SERVICE BULLETIN NO: 27-015

MODIFICATION NO: 020346

FLIGHT CONTROLS - FLAPS REPLACEMENT OF INBOARD AND OUTBOARD FLAP FLEXSHAFTS

Flap Flexshafts - Installation
 Figure 1 (Sheet 1 of 3)

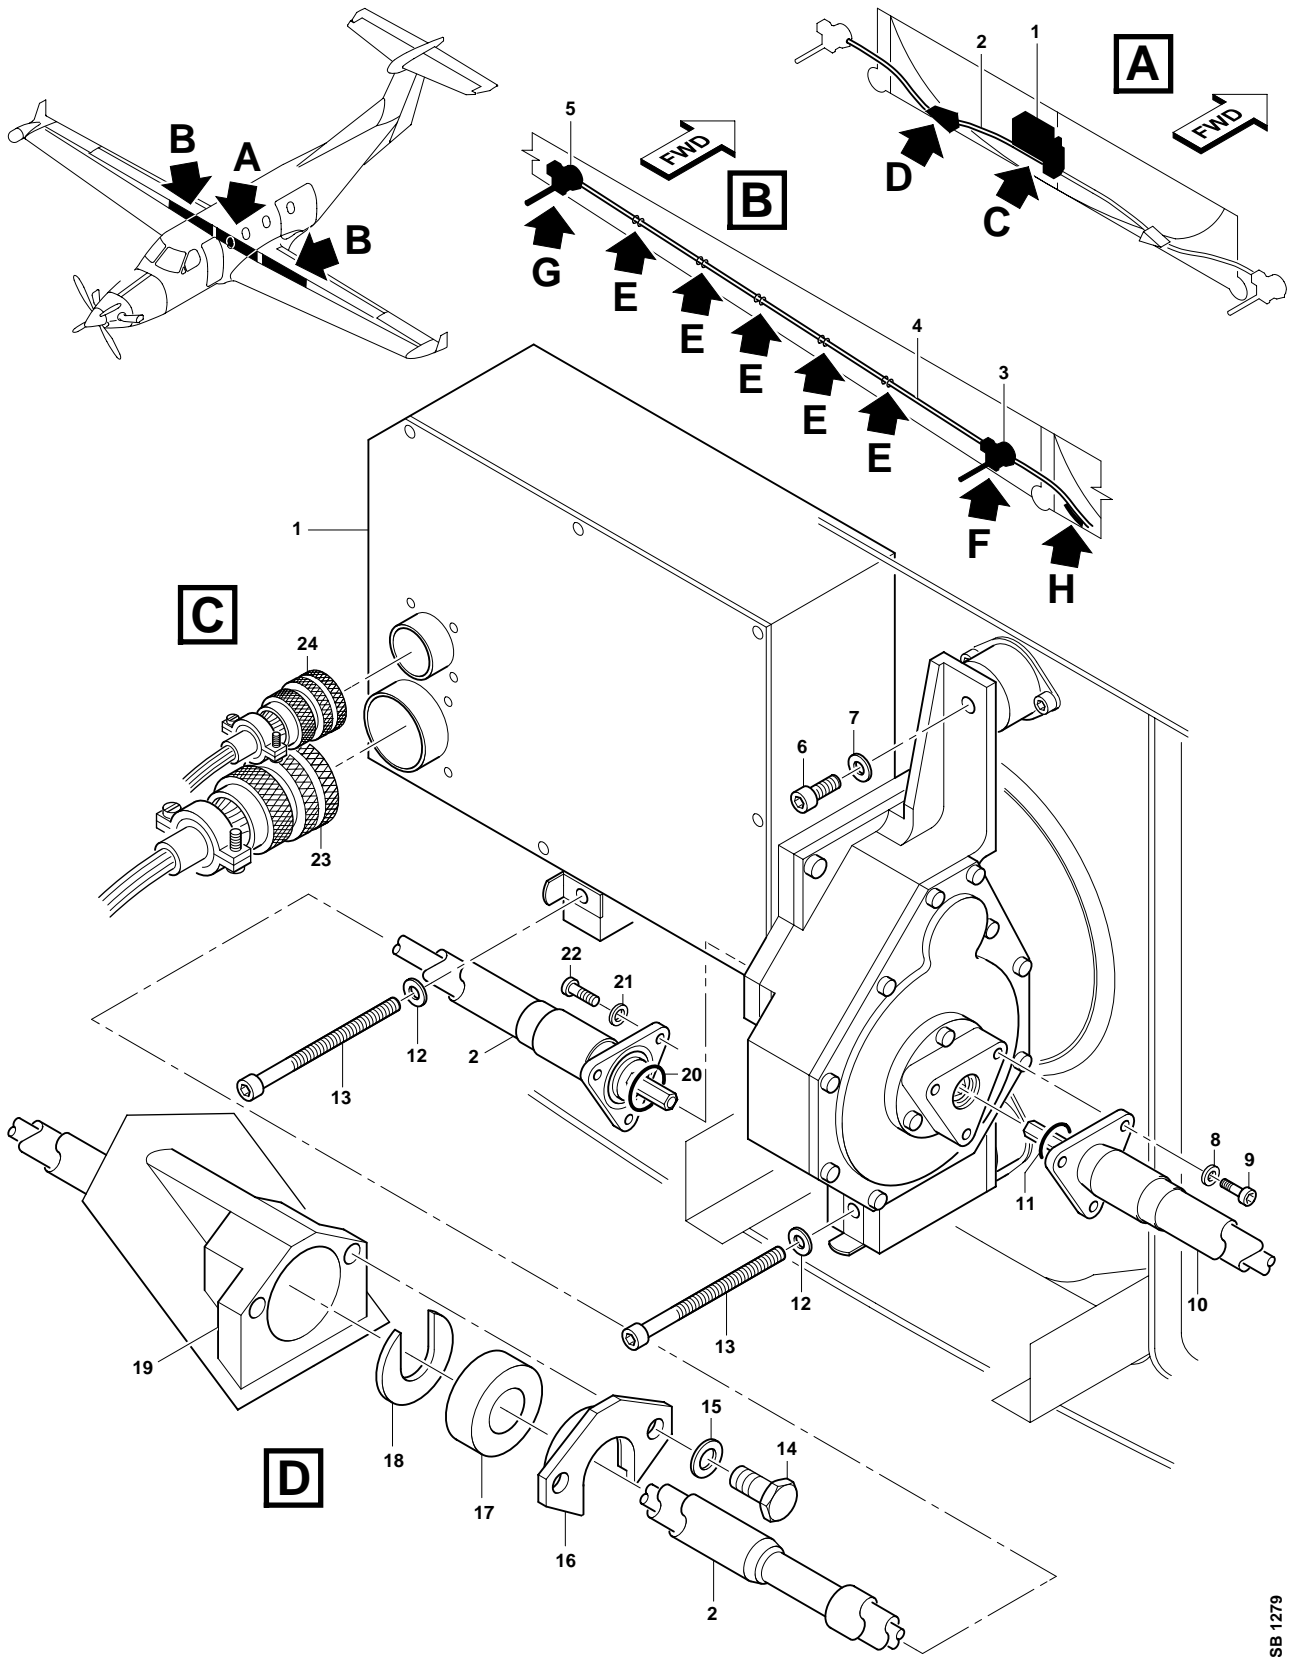
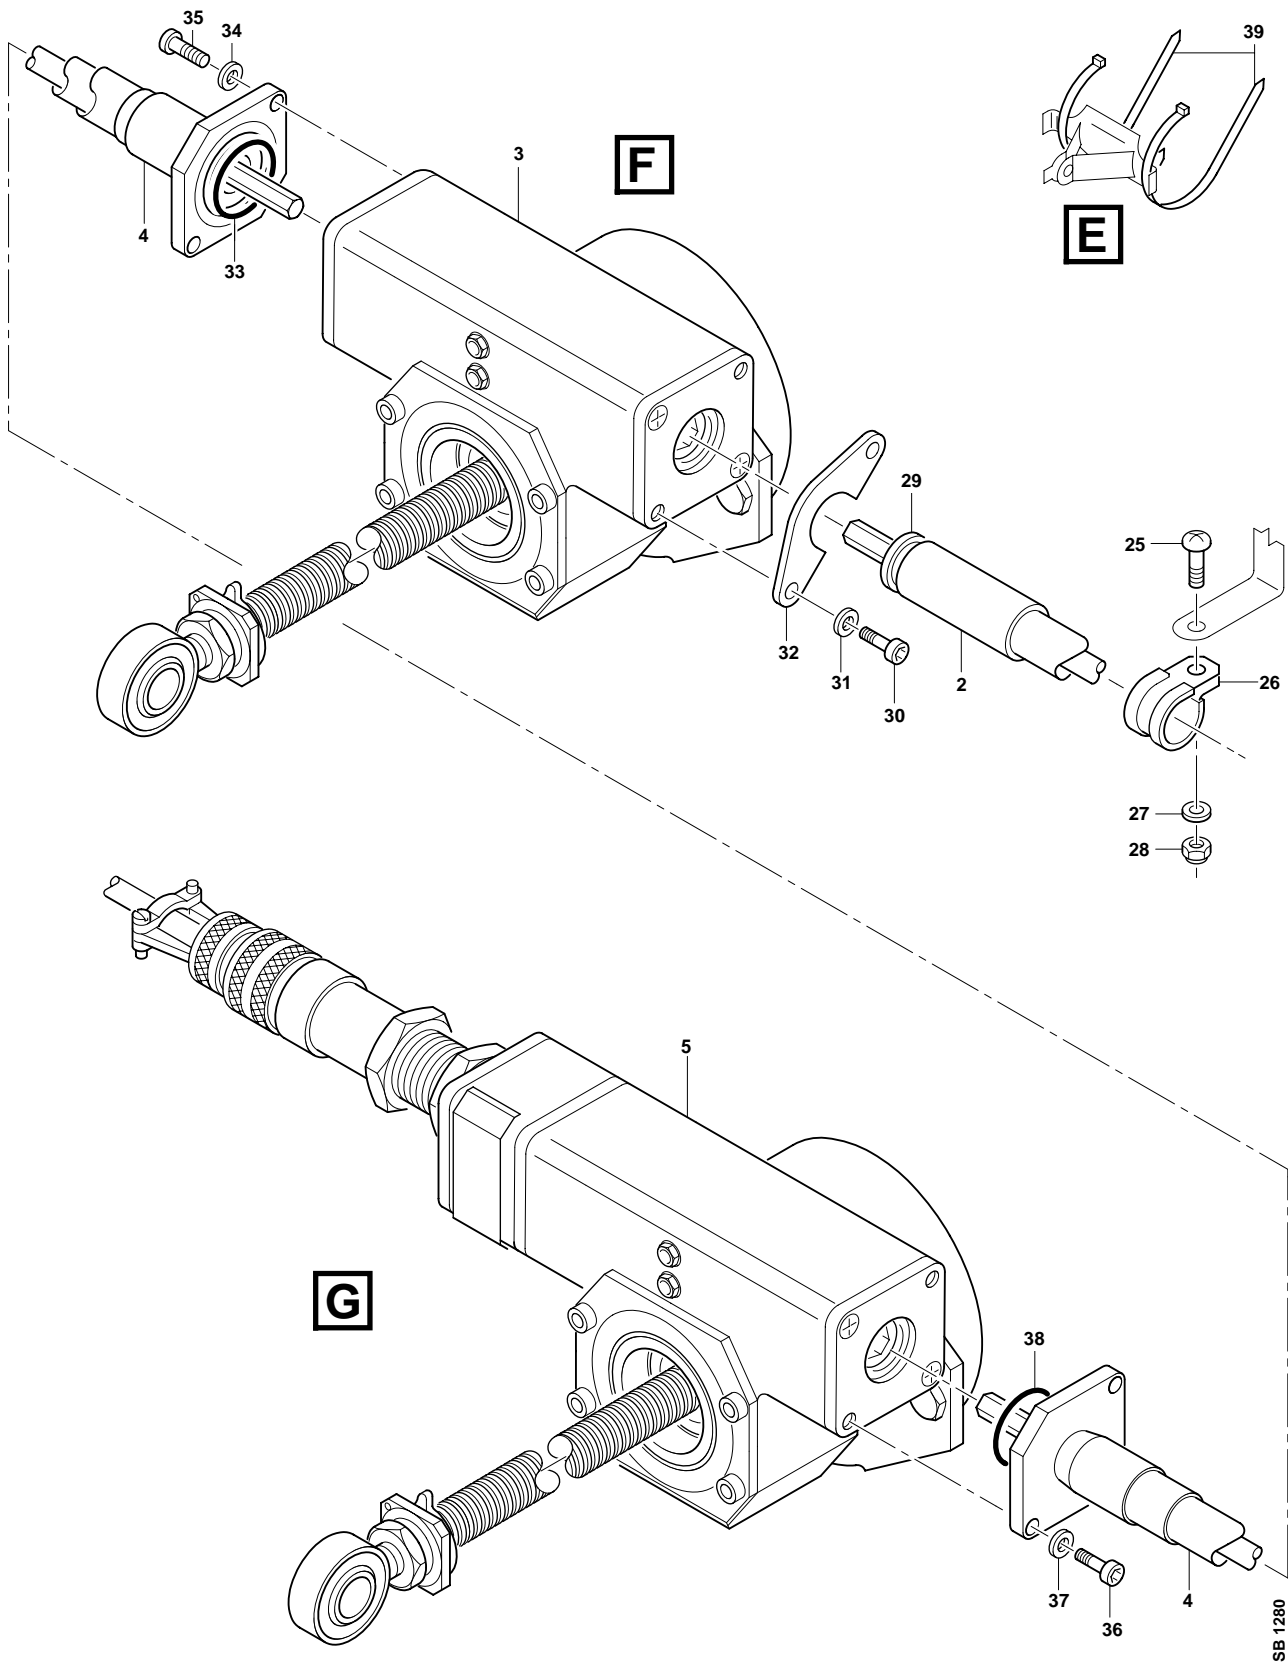
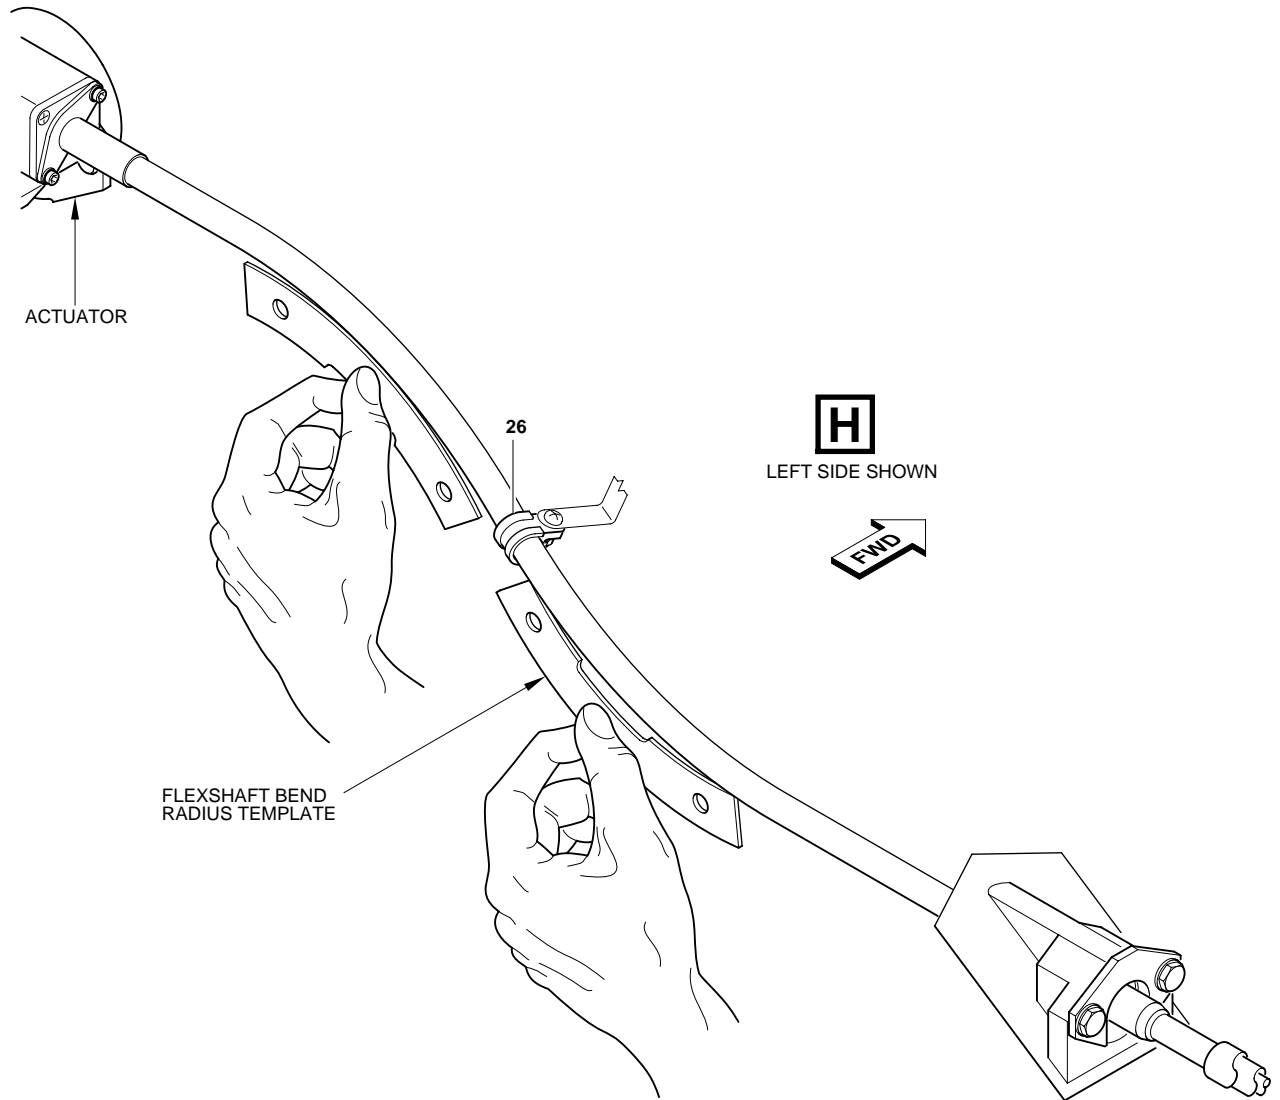
It is possible for moisture to go into the inboard and outboard flexshafts through the fittings of the protection hose. This can cause corrosion of the flexshafts.

Install new flap flexshafts of improved design that give a better protection-hose seal.

This Service Bulletin gives the instructions necessary to remove flap flexshafts 945.02.02.203 and 945.02.02.204 and install flap flexshafts 945.02.02.205 and 945.02.02.206.

Flexshafts 945.02.02.205 and 945.02.02.206 supersede flexshafts 945.02.02.203 and 945.02.02.204. Do not install (blue) flexshafts 945.02.02.203 and 945.02.02.204.

Pre and Post SB 27-015 (blue) flexshafts are not interchangeable.

(1) Install the left inboard flexshaft (2)

- (a) Examine the shaft lock (32) and replace if worn.
- (b) Obey the manufacturers instructions and apply anti-seize compound (Material No. P04-029) to the threads of the screws (9) and (22).

- (c) Make sure the seal (20) is in position and attach left flexshaft (2) to the PDU (1) with the screws (22) and washers (21).
- (d) Safety the screws (22) with lockwire (Material No. P02-007).

- (e) Examine the rubber disc (17) and replace if damaged.
- (f) Put the rubber disc (17) on the flexshaft (2).
- (g) From inside the fuselage, put the flexshaft (2) through the bulkhead connector (19).

- (h) Install locking ring (18) and the rubber disc (17) on to the bulkhead connector (19).
- (i) Put the PDU (1) in position and install the screws (13) and washers (12).

- (j) Install the screw (6) and washer (7).
- (k) Safety the screws (6) and (13) with lockwire (Material No. P02-007).
- (l) Examine the seal (11) and replace if damaged.

- (m) Make sure the seal (11) is in position and connect the right flexshaft (10) to the PDU (1) with the screws (9) and washers (8).

- (n) Safety the screws (9) with lockwire (Material No. P02-007).
- (o) Connect the electrical connectors (23) and (24) to the PDU (1).

(2) Install the right inboard flexshaft (10)

- (a) Install the flange (16), bolts (14) and washers (15) on the bulkhead connector (19).
- (b) Make sure the seal (29) is in position and install flexshaft (2) to the flap screw actuator (3) with the shaft lock (32), screws (30) and washers (31).

- (c) Safety the screws (30) with lockwire (Material No. P02-007).
- (d) Install the clamp (26) on the flexshaft (2) with the screw (25), washer (27) and nut (28).

- (e) Use the bend radius template (513.27.12.066) do a check of the flexshaft routing. Make sure the radius of all bends in the flexshaft is greater than that of the bend radius template. You can use the:

- (a) Put the flexshaft (4) through the wing trailing-edge ribs.
- (b) Obey the manufacturers instructions and apply anti-seize compound (Material No. P04-029) to the threads of the screws (35) and (36).
- (c) Make sure the seal (33) is in position and install the flexshaft (4) in the inboard flap screw actuator (3).
- (d) Install the two screws (35) and washers (34).

- (e) Safety the screws (35) with the lockwire (Material No. P02-007).
 - (f) Make sure the seal (38) is in position and install the flexshaft (4) in the outboard flap screw actuator (5).
 - (g) Install the two screws (36) and washers (37).
 - (h) Safety the screws (36) with the lockwire (Material No. P02-007).
 - (i) Install, but do not tighten, the cable ties (39) (Material No. P09-014) on the flap drive shaft (4).
- (5) Remove the DO NOT OPERATE THE FLAPS warning sign.
 - (6) Remove the safety clip and close the circuit breaker:
CB 034 (FLAP PWR)
 - (7) Do the functional test of the flap system (Ref. AMM, 27-50-00, Page Block 501).
